**Addendum to: STORMWATER DETENTION ANALYSIS
PREPARED BY: BAX ENGINEERING CO., INC.**

LAKESIDE ESTATES - O'FALLON

BAX PROJECT NO. 89-3094C

February 25, 1999

MODIFICATIONS TO EXISTING STRUCTURE

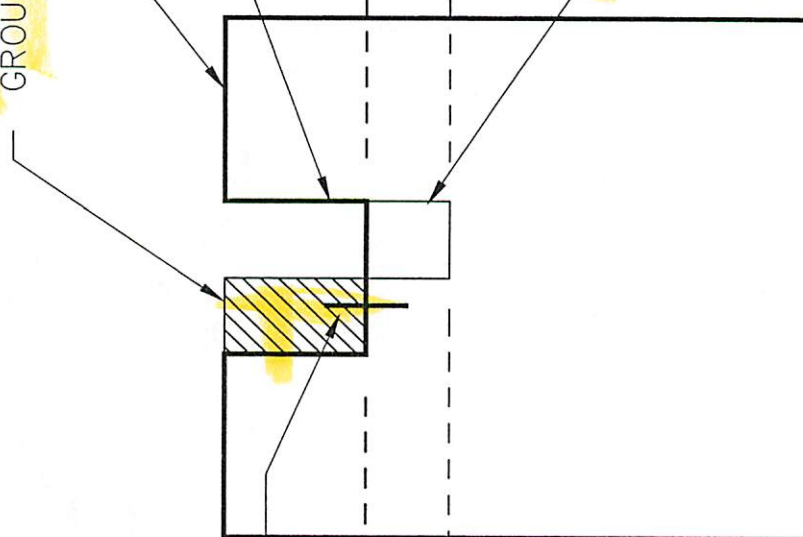
FILL-IN WITH P.C. CONCRETE OR
GROUT TO NARROW SLOT TO 6"

EXISTING TOP 517.18 TO REMAIN

12" WIDE x 15" HIGH SLOT
F.L. = 515.93

EXISTING LAKE LEVEL 515.93

PROPOSED LAKE LEVEL 515.50

SAW-CUT AND REMOVE 5"
SECTION TO ELEVATION 515.50
6" WIDE

8" #3 DOWEL GROUDED
TO EX. STRUCTURE

This report is in addendum to a previously submitted report dated April 7, 1995 and revised April 17, 1995. In order to provide adequate detention, the structure must be narrowed to 6" and lowered approximately 5". Page four of the previous report indicated that the lake outflow shall be limited to 23 cfs (15 year- 20 minute *undeveloped* flow to the lake). As this analysis shows, the 2, 25, and 100 year-20 minute outflows are below 23 cfs. 2.25 feet of freeboard is provided during the 100-year design storm.
